Auckland Transport
Attention: Have your say, Jonathan Levell, Scott Ebbett

# SUBMISSION TO THE INTRODUCTION OF PAID PARKING IN PARNELL

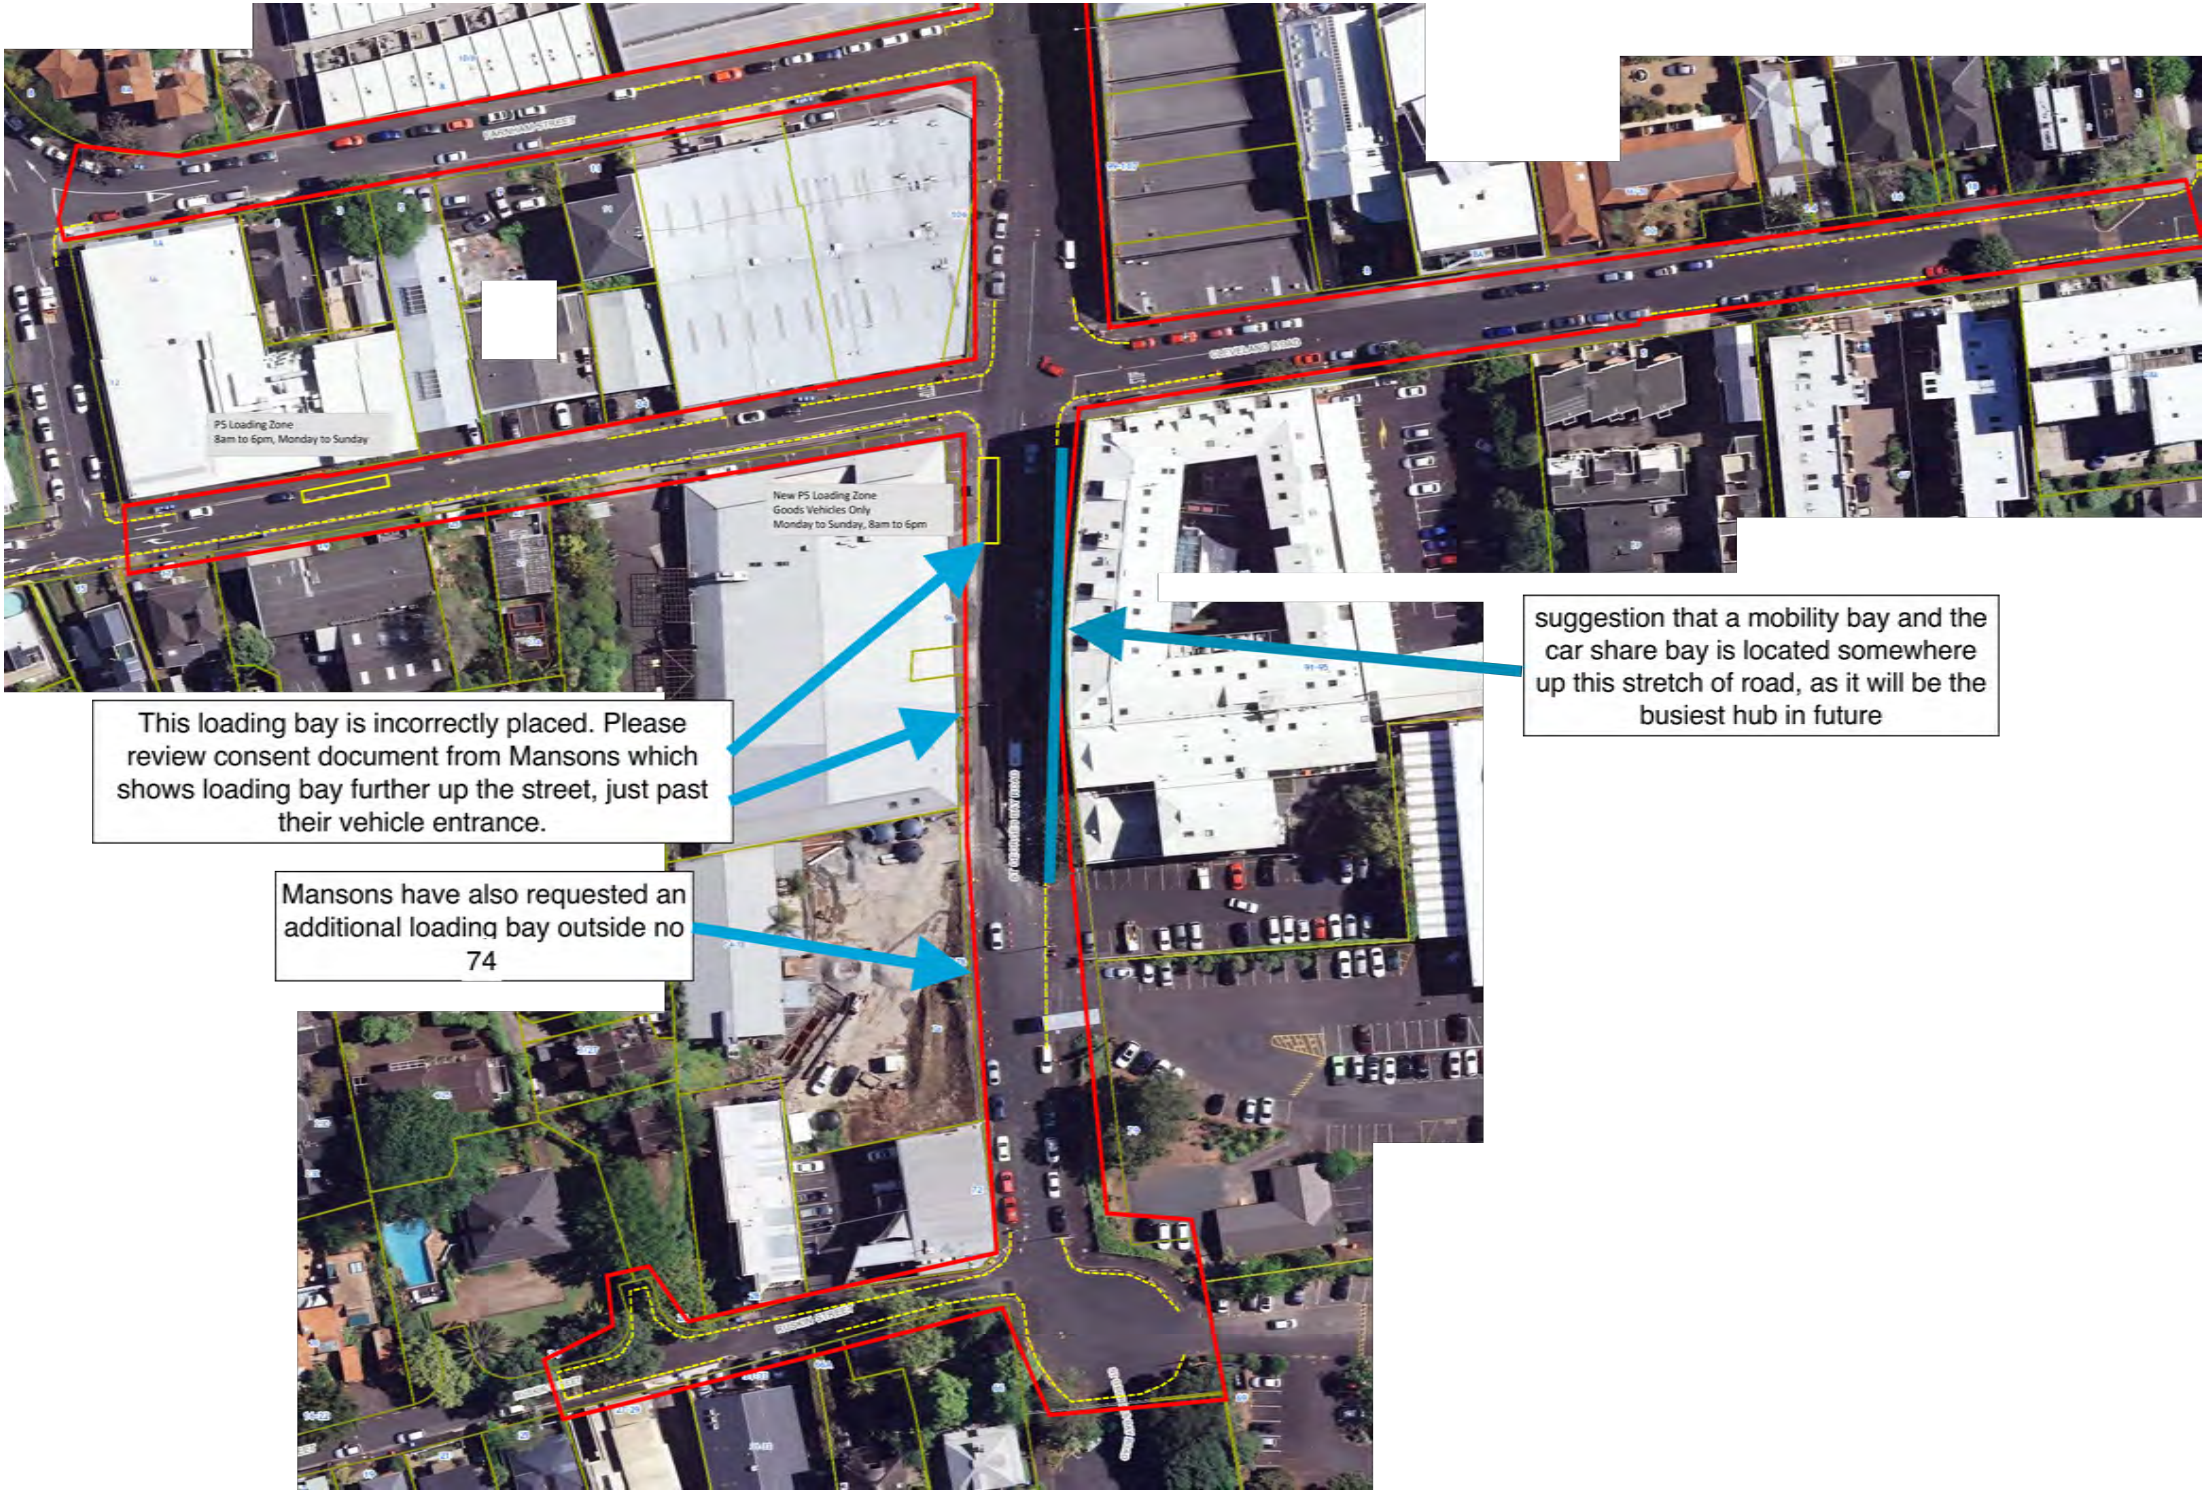
PS Loading Zone
8am to 6pm, Monday to Sunday
New PS Loading Zone
Goods Vehicles Only
Monday to Sunday, 8am to 6pm
This loading bay is incorrectly placed. Please review consent document from Mansons which shows loading bay further up the street, just past their vehicle entrance.
Mansons have also requested an additional loading bay outside no 74
suggestion that a mobility bay and the car share bay is located somewhere up this stretch of road, as it will be the busiest hub in future

RC-1301 GROUND LEVEL PLAN
Rev.D 29/06/15

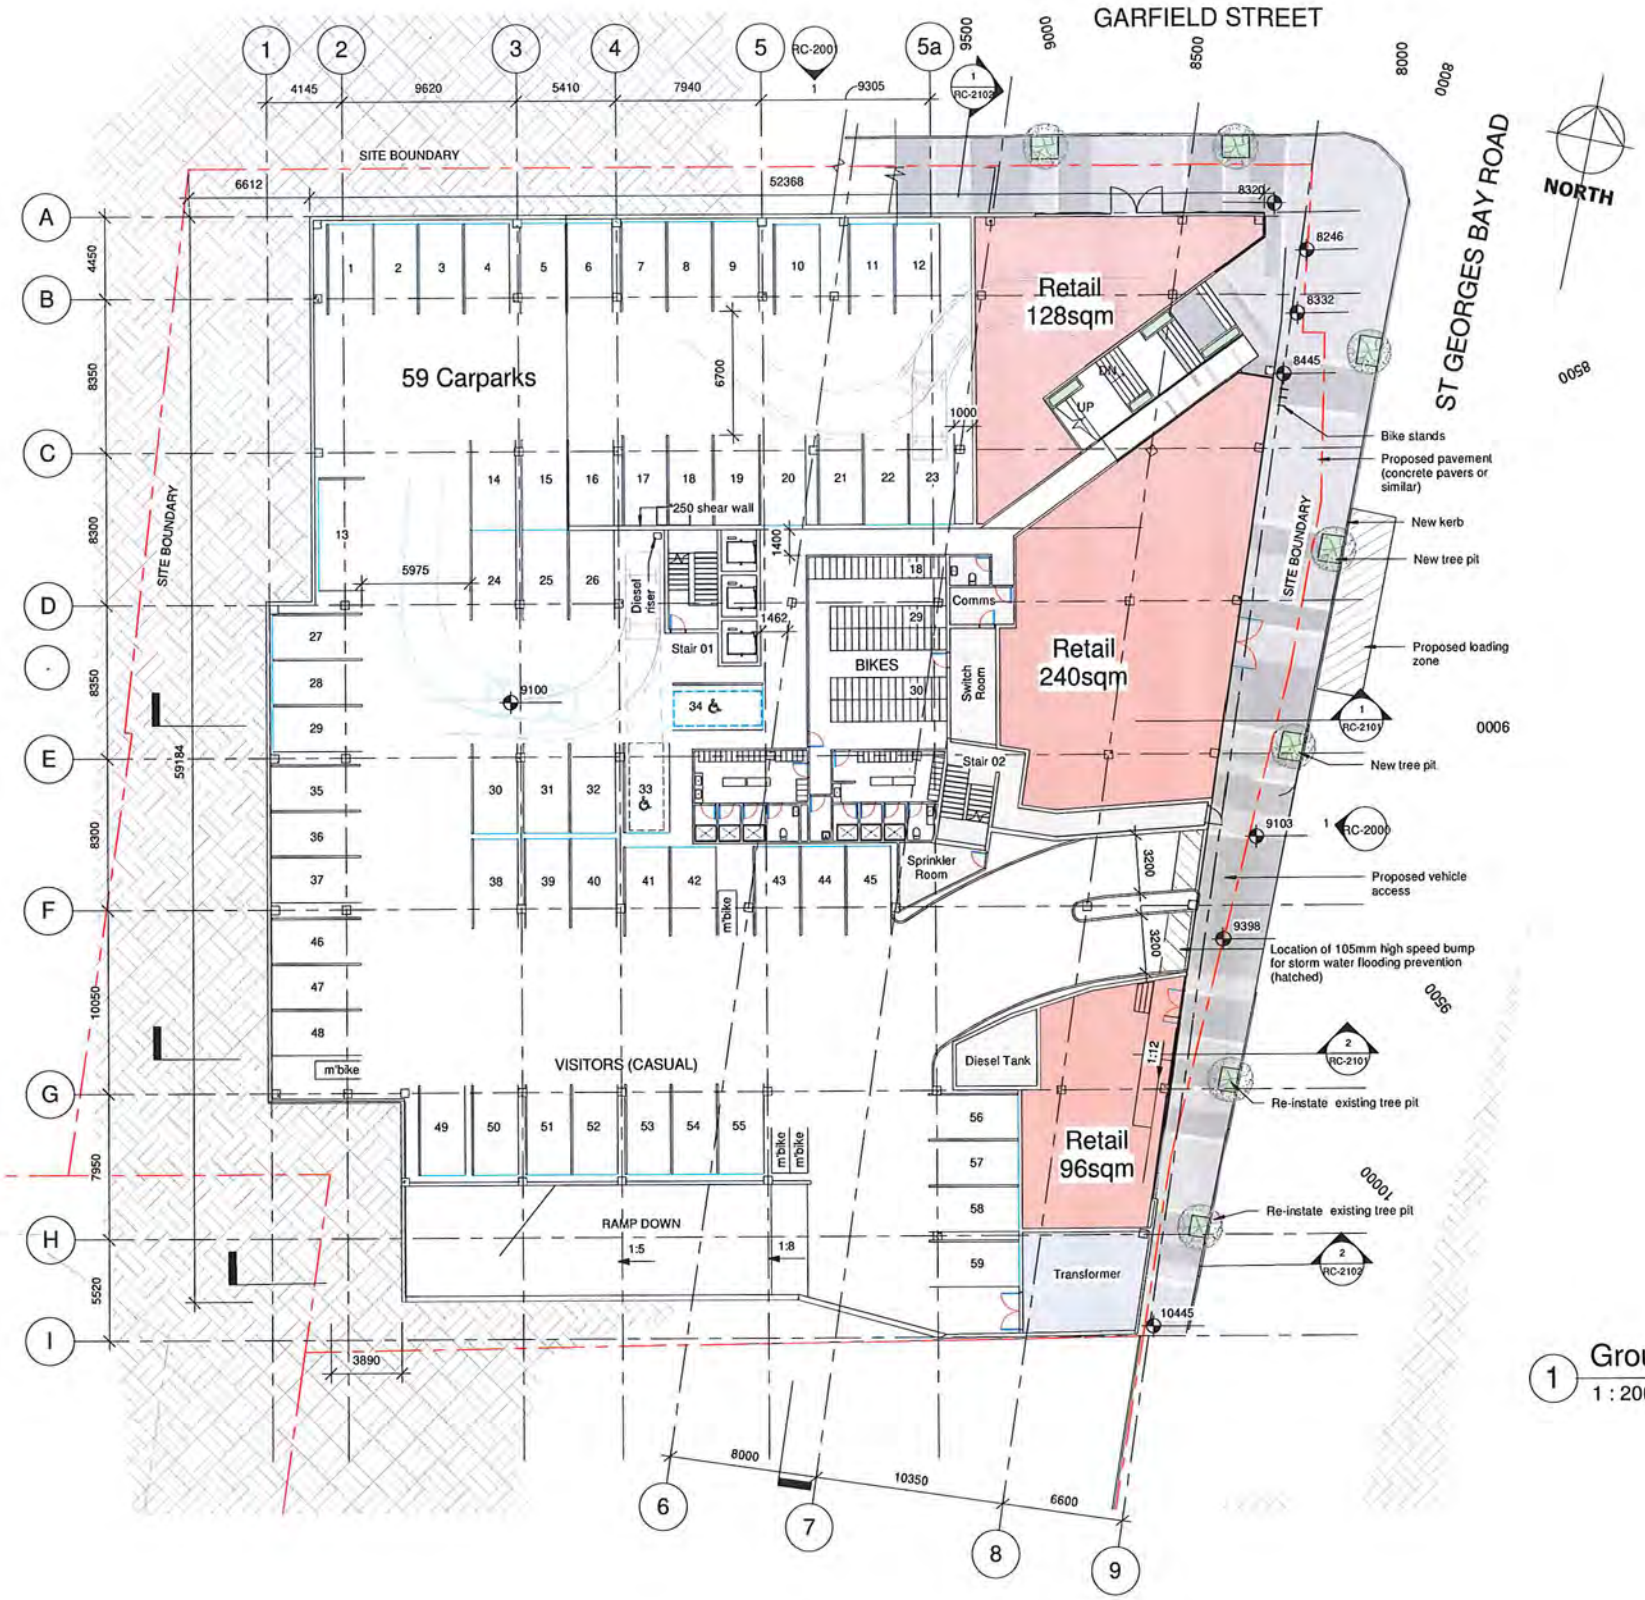
| Mansons TCLM Limited | Refer approved plans for 96 and 74. 96 plan the loading zone is shown just north of our vehicle crossing. This is probably the best place to service the site, given the main entrance is at the corner and it is also opposite the axis building etc.The second plan is 74, we would like a loading zone outside this site as well if that is on the cards? We have a vehicle crossing at the northern end of the site, but the rest of the frontage is available. |
